Mr Mee Access table prepared by Peter Cole of Ceres Property

Accesses - Retained Land Affected by Lower Thames Crossing

PLAN 3

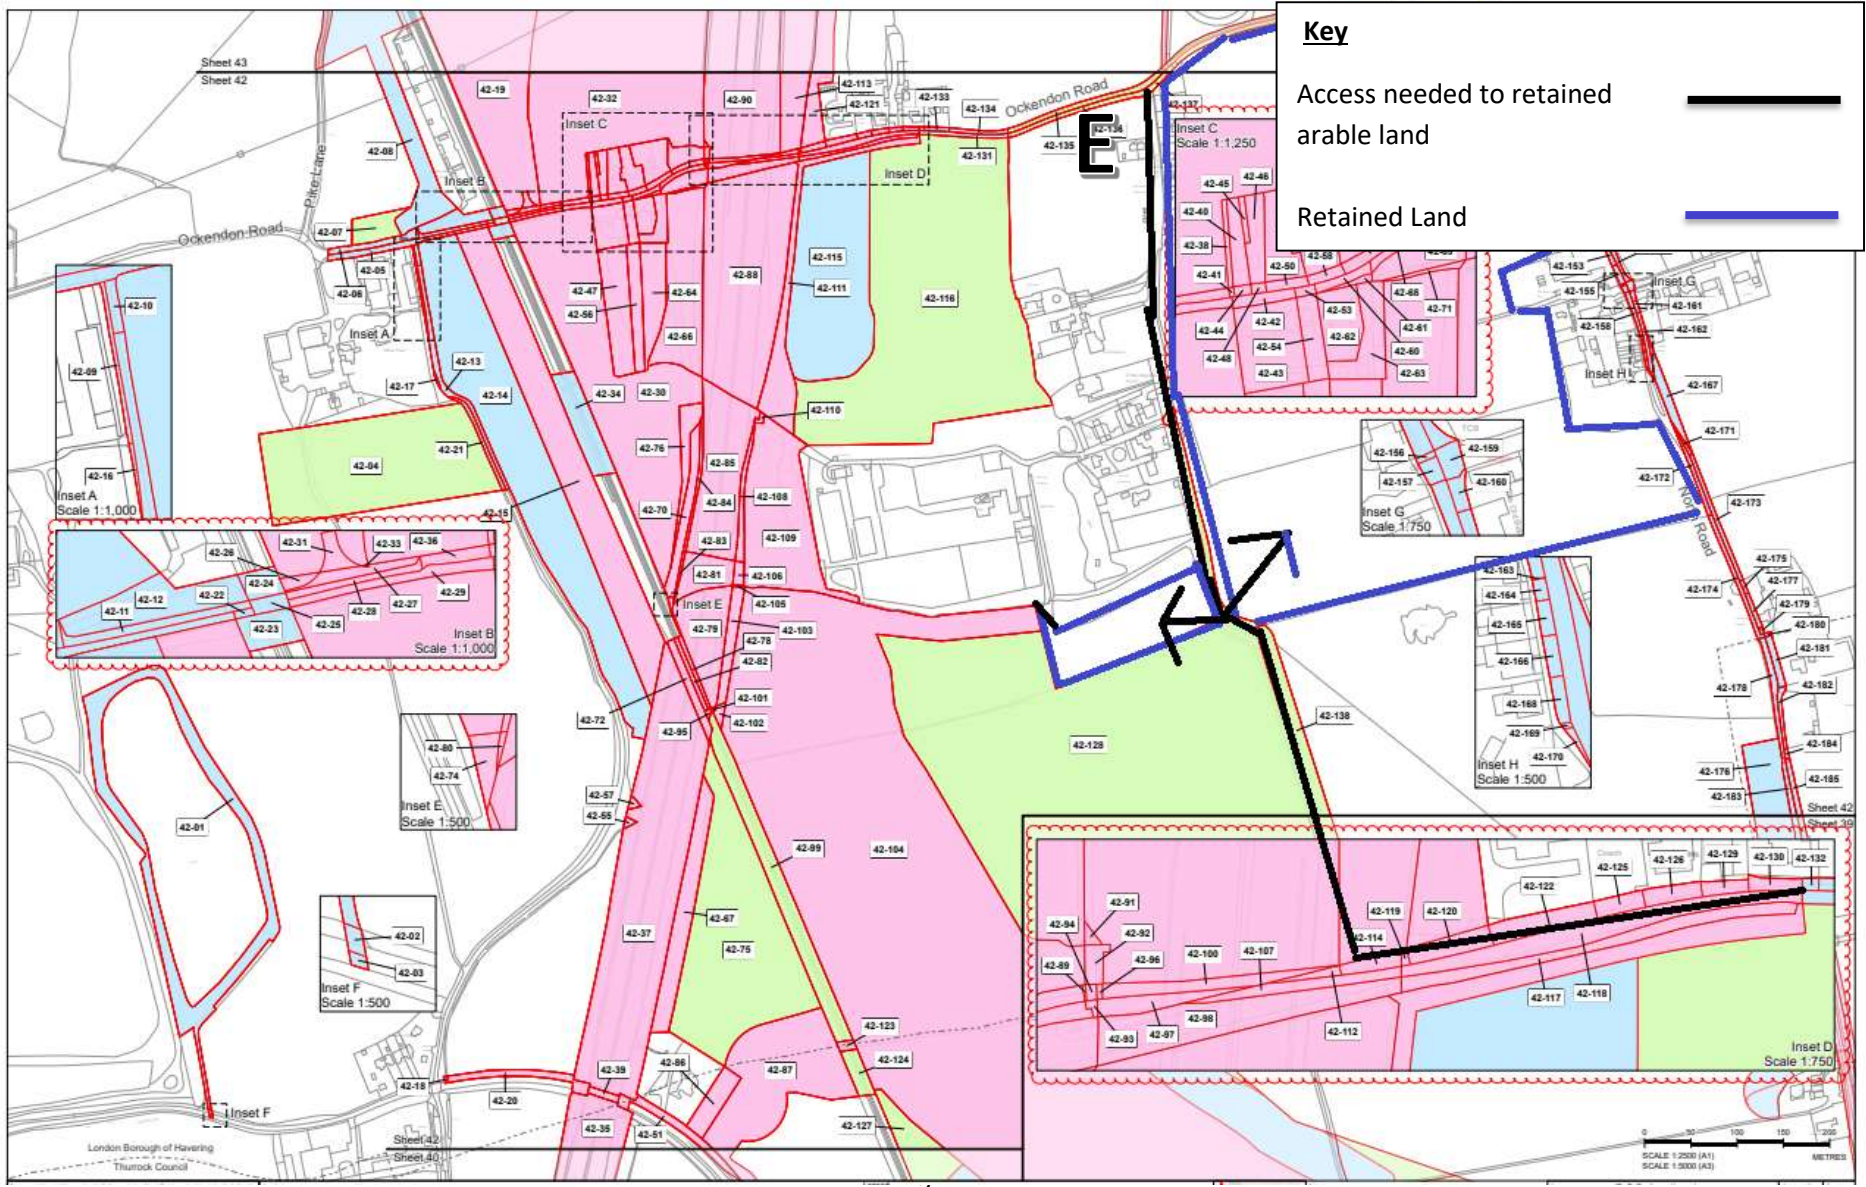
Applicant's Plan which has been annotated by Peter Cole	Plan 2	Plan 3	Plan 4
Current Access	Access to the field outlined in purple is currently taken from North Road by "Redcroft Forge", further south and over the arable fields.	Access to the field outlined in purple is currently taken from North Road by "Redcroft Forge", further south and over the arable fields.	Access to the field outlined in purple is currently taken from Ockendon Road, over the arable field known has Hobbs Hole Field and over Pike Lane.
Applicant's proposed replacement access to allow continued use of retained arable land	Point D on the above plan	Point E on the above plan	Point F on the above plan but not provided by the Applicant.
Description of Applicant's proposed replacement access	There is an existing access where the Applicant proposes to provide its replacement access which is Approx 4 metres in width	There is an existing access (entrance of Church Lane) where the Applicant proposes to provide its replacement access which is Approx 14 metres in width	Access is barred

Effects of LTC Scheme, and comments on the suitability of replacement access	<p>Lower Thames Crossing will sever the current access through the arable fields.</p> <p>There is an existing access to the arable land from North Road at "Point D" which the Applicant has proposed as the main access point to the arable land. A new WCH is also</p>	<p>Lower Thames Crossing will sever the current access through the arable fields.</p> <p>There is an existing access from Ockendon Road at "Point E" which the Applicant has proposed as the main access point to the arable land.</p>	<p>Lower Thames Crossing will sever the current access.</p> <p>There is no designed access to this retained land and access is barred.</p> <p>Access up Pike Lane is not suitable for</p>

<p>proposed that will interact with this access, and it will be used as a maintenance track by the Applicant.</p> <p>Applicant’s proposed access is not suitable:</p> <ol style="list-style-type: none"> 1. For safety reasons with the interaction with vehicles using North Road and the property known as 4 Groves Farm Cottages. 2. The access is currently not wide enough nor suitable for modern agricultural equipment. 3. It will not prevent unauthorised access. 	<p>Applicant’s proposed access is not suitable:</p> <ol style="list-style-type: none"> 1. For safety reasons as Church Lane does not provide a suitable width for agricultural equipment because of residents parking their vehicles on the roadside. 	<p>agricultural equipment with the width restrictions and crossing over the Railway bridge. Access down Pike Lane is not suitable for agricultural equipment with the width restrictions and the distance from the farmstead.</p>

<p>Mr Mee's need for new access</p>	<p>Access to this land is required of at least 5 metres in width and suitable for a turning circle to cater for farm vehicles and machinery (e.g. combine and tractor and trailers). This may need to be wider to comply with highway safety requirements i.e the need for visibility splays to ensure that it is safe.</p> <p>Access to the land will need to provide suitable security measures i.e. a reinforced gate with poacher blocks to prevent unauthorised access.</p> <p>It is the case in this part of south Essex, near to a large urban conurbation and easy main routes of road access that the pressure from unauthorised users is evidently of such a degree that when barriers have been used, they have been damaged.</p> <p>We are unaware of how often this access track will be used by the Applicant for maintenance and if passing bays will need to be provided if this access will be shared. It is unclear how the WCH will interact with the agricultural access as we don't know the design requirements of the WCH.</p>	<p>Should "Point E" be used, then Church lane would need to be widened to accommodate agricultural equipment and allow residents to park their vehicles on the roadside.</p> <p>The Applicant needs to provide an access from "Point D" from North Road. This will need to be at least 5 metres in width and suitable for a turning circle to cater for farm vehicles and machinery (e.g. combine and tractor and trailers). This may need to be wider to comply with highway safety requirements i.e the need for visibility splays to ensure that it is safe. Access from North Road at "Point D" will need to provide suitable security measures i.e. a reinforced gate with poacher blocks to prevent unauthorised access.</p> <p>The Applicant needs to provide an access track which is at least 5 metres in width from "Point D" to connect into this land. If the access track is to be shared with the Applicant we need to know how often this access track will be used for maintenance an construction and if passing bays will need to be provided if this access will be shared.</p>	<p>Access to this land at "Point F" is required of at least 5 metres in width and suitable for a turning circle to cater for farm vehicles and machinery (e.g. combine and tractor and trailers). This may need to be wider to comply with highway safety requirements i.e the need for visibility splays to ensure that it is safe.</p> <p>Access to the land will need to provide suitable security measures i.e. a reinforced gate with poacher blocks to prevent unauthorised access.</p> <p>It is the case in this part of south Essex, near to a large urban conurbation and easy main routes of road access that the pressure from unauthorised users is evidently of such a degree that when barriers have been used, they have been damaged.</p> <p>We are unaware of how often this access track will be used by the Applicant for maintenance and if passing bays will need to be provided if this access will be shared.</p>

<p>Proposal for access</p>	<ol style="list-style-type: none"> 1. There is no detailed design on the specifications requested above. 2. There is no detail on for a shared access between the Applicant and our Client during construction and there should be no conflict with use of the track to allow the land to be farmed. 3. There is no detailed design on the how the WCH will interact with the access and how unauthorised access can be prevented. 	<ol style="list-style-type: none"> 1. There is no detailed design on the specifications requested above. 2. Mr Mee would need to use "Point D" and can not use "Point E" unless Church Lane is widened. 3. There is no detail on a shared access between the Applicant and our Client during construction and there should be no conflict between access for construction and to use the track to access the land for farming. 	<ol style="list-style-type: none"> 1. An access to this land in line with the specifications requested above. 2. Detailed design on the specification requested above 3. There is no detail on a shared access between the Applicant and our Client and there should be no conflict between access for maintenance and to use the land for access to farm the arable field.

PLAN 4

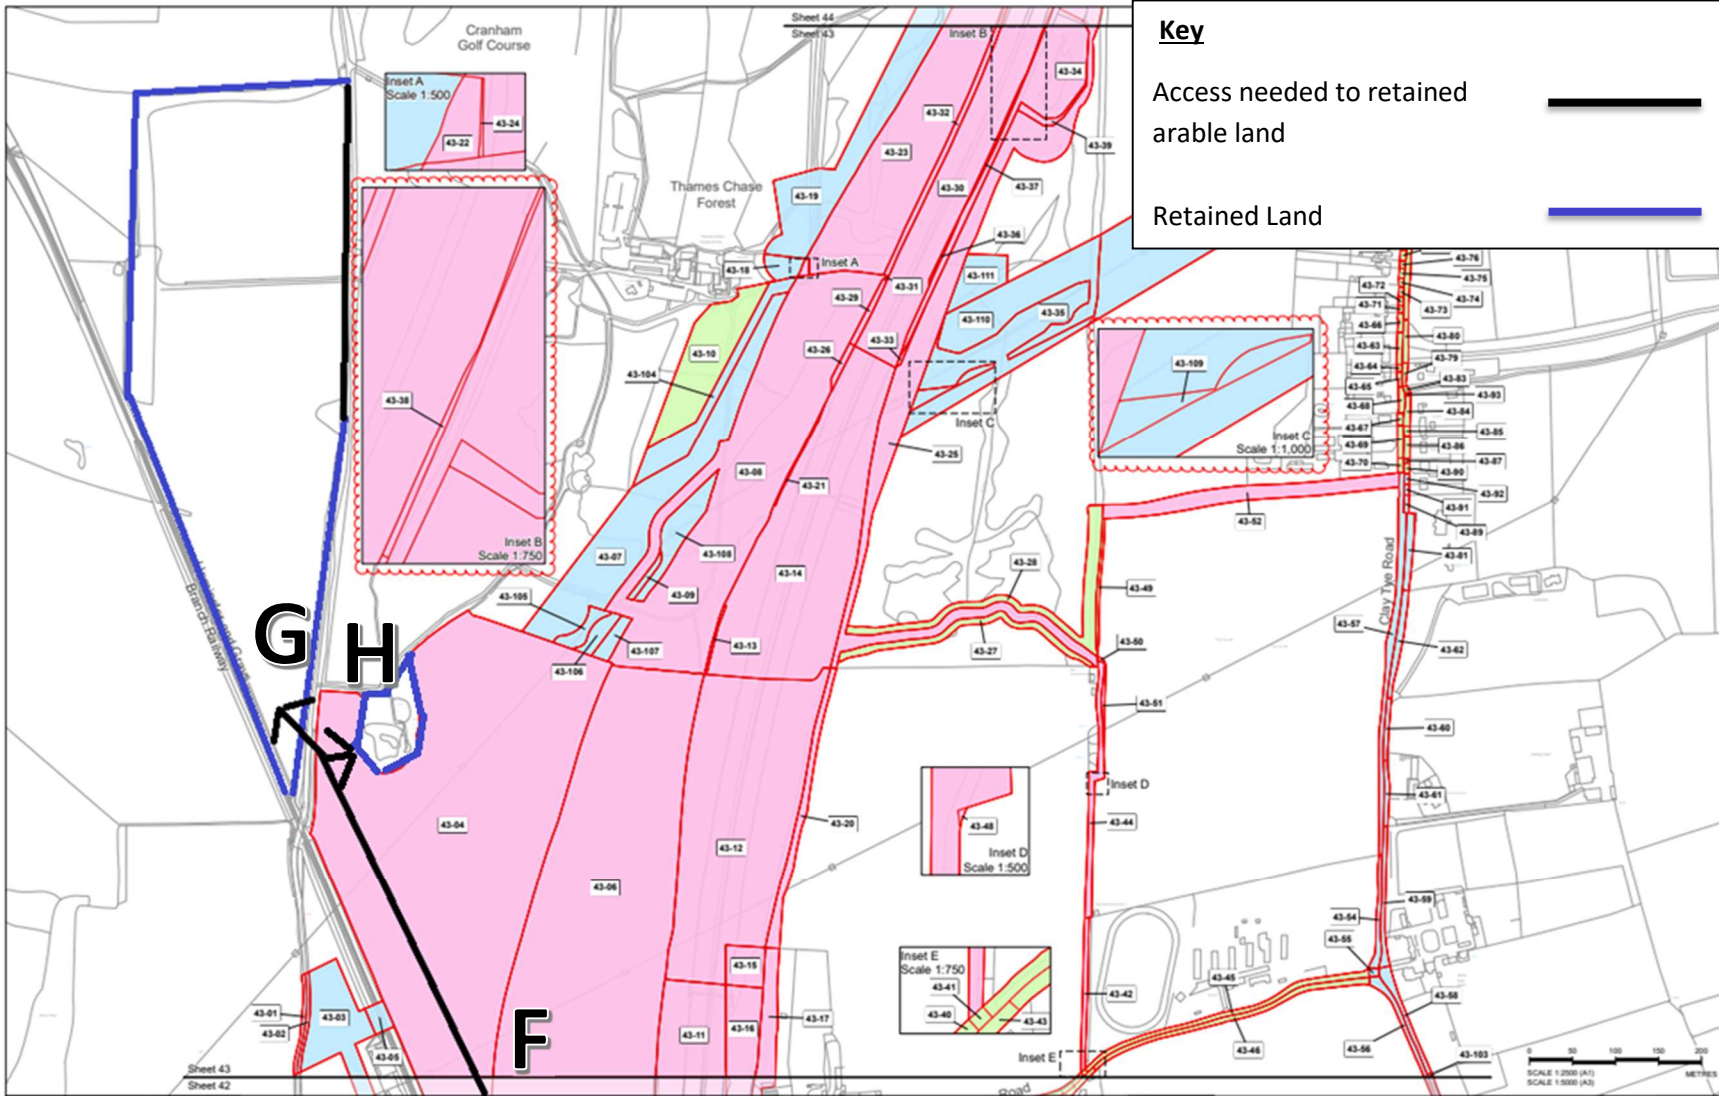
Applicant's Plan which has been annotated by Peter Cole	Plan 4	Plan 4	Plan 5
Current Access	Access to the field outlined in purple is currently taken from Ockendon Road, over the arable field known as Hobbs Hole Field and over Pike Lane.	Access to the pond known as Hobb Hole Pond is currently from Pike Lane.	Access to the field outlined in purple is currently from Ockendon Road. The track is owned by National Highways as part of the M25 construction and our client has an all-purpose right of way over the track to farm the land.
Applicant's proposed replacement access to allow continued use of retained arable land	Point G on the above plan	Point H on the above plan	Point I on the above plan
Description of Applicant's proposed replacement access	Access is barred	Access is barred	There is an existing access where the Applicant proposes to provide its replacement access which is Approx 7 metres in width

Effects of LTC Scheme, and comments on the suitability of	Lower Thames Crossing will sever this current access. There is no designed access to this retained land and access to the land would be severed.	Lower Thames Crossing will sever this current access. There is no designed access to this retained	The land is proposed to be permanently acquired to accommodate a WCH route.

<p>replacement access</p>	<p>Access up Pike Lane is not suitable for agricultural equipment with the width restrictions and crossing over the Railway bridge. Access down Pike Lane is not suitable for agricultural equipment with the width restrictions and the distance from the farmstead.</p>	<p>pond and access to the pond would be severed.</p>	
<p>Photo from Roadside</p>			
<p>Orientation of Photo</p>	<p>Looking north west along Pike lane with "Point G" to the left hand side.</p>	<p>Looking east at Pike lane to access Hobbs Hole Pond.</p>	<p>Looking east on Ockendon road with "Point I" on the right hand side.</p>
<p>Result of lost access</p>	<p>There is no access provided by the Applicant. Without one Mr Mee cannot farm the land.</p>	<p>There is no access provided by the Applicant. Without one Mr Mee cannot let the pond out for fishing or use it.</p>	<p>The track is scheduled to be permanently acquired removing Mr Mee's access rights over this track. Without access rights, Mr Mee will not be able to farm the land.</p>

<p>Mr Mee's need for new access</p>	<p>Access to this land at "Point F" is required of at least 5 metres in width and suitable for a turning circle to cater for farm vehicles and machinery (e.g. combine and tractor and trailers). This may need to be wider to comply with highway safety requirements i.e the need for visibility splays to ensure that it is safe.</p> <p>We require an access from "Point G" of at least 5 metres in width to come off the arable field known as Hobbs Hole onto Pike Lane. This may need to be wider to comply with highway safety requirements i.e the need for visibility splays to ensure that it is safe.</p>	<p>Access to this pond at "Point H" will need to be at least 4 metres in width and suitable for a turning circle to cater for domestic vehicles. This may need to be wider to comply with highway safety requirements i.e the need for visibility splays to ensure that it is safe.</p> <p>Access to the land will need to provide suitable security measures i.e. a reinforced gate with poacher blocks to prevent unauthorised access.</p> <p>It is the case in this part of south Essex, near to a large urban conurbation and easy main routes of road access that the pressure from unauthorised users is evidently of such a degree that when barriers have been used, they have been damaged.</p>	<p>The existing access and track is sufficient for agricultural equipment and needs to remain.</p> <p>It is unclear how the WCH will interact with the agricultural access as we don't know the design requirements of the WCH.</p> <p>The applicant will need to provide an all-purpose right of way on the track to ensure the track can continue to be used by Mr Mee to access his arable fields.</p> <p>Access to the land will need to provide suitable security measures i.e., a reinforced gate with poacher blocks to prevent unauthorised access.</p> <p>It is the case in this part of south Essex, near to a large urban conurbation and easy main routes of road access that the pressure from unauthorised users is evidently of such a degree that when barriers have been used, they have been damaged.</p> <p>The Applicant will need to ensure the safe passage of any WCH users onto Ockendon Road which is a busy road with blind corners.</p>

<p>Overall conclusions on Applicant Proposal for access</p>	<p>The Applicant has not provided an access to this land. The Applicant will need to provide:</p> <ol style="list-style-type: none"> 1. An access to this land in line with the specifications requested above. 2. Detailed design on the specification requested above 	<p>The Applicant has not provided an access to this pond. The Applicant will need to provide:</p> <ol style="list-style-type: none"> 1. An access to the pond in line with the specifications requested above. 2. Detailed design on the specification requested above 	<p>The Applicant has not provided access rights to this land. The Applicant will need to provide:</p> <ol style="list-style-type: none"> 1. An access to the land in line with the existing specifications 2. Detailed design on the specification requested above 3. There is no detailed design on the how the WCH will interact with the access and how unauthorised access can be prevented.
